TRANSPORTATION PLANNING REVIEW

EP # 2020-13400

Address of Site: 18611 NW Sauvie Island Rd

SUBJECT: **EP-2020-13340, 18611 NW Sauvie Island Rd
R971170130/R324976**

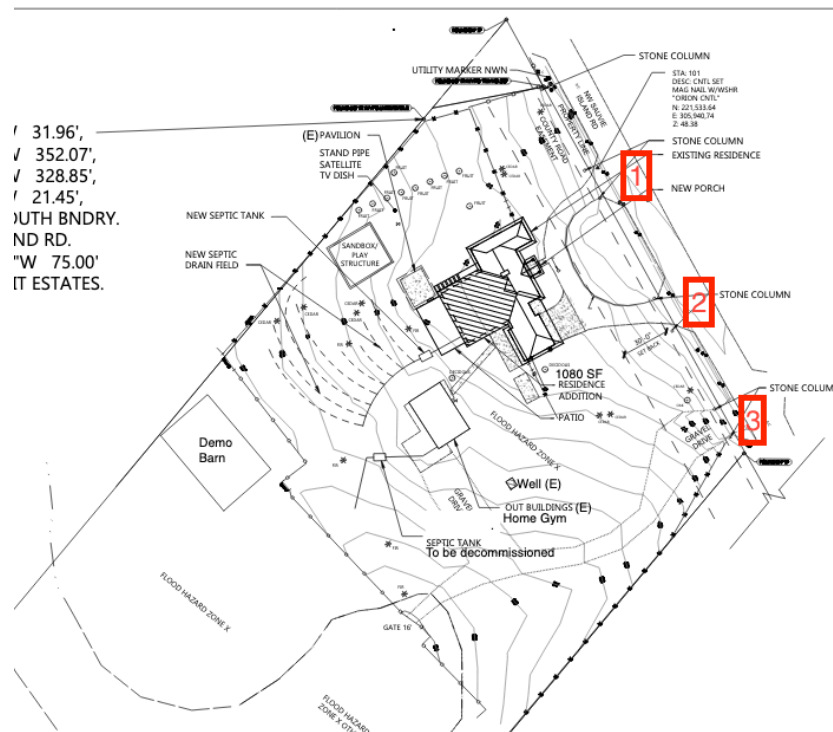
Meet County standards of one access per property [MCRR 3.000] or a) apply for an ENCA or b) a Road Rules Variance to retain the existing access points.

The submitted plan showed three existing accesses to the property. This exceeds the County's MCRR standard of one access per property. See annotated excerpt of the submitted site plan below showing the three access points.
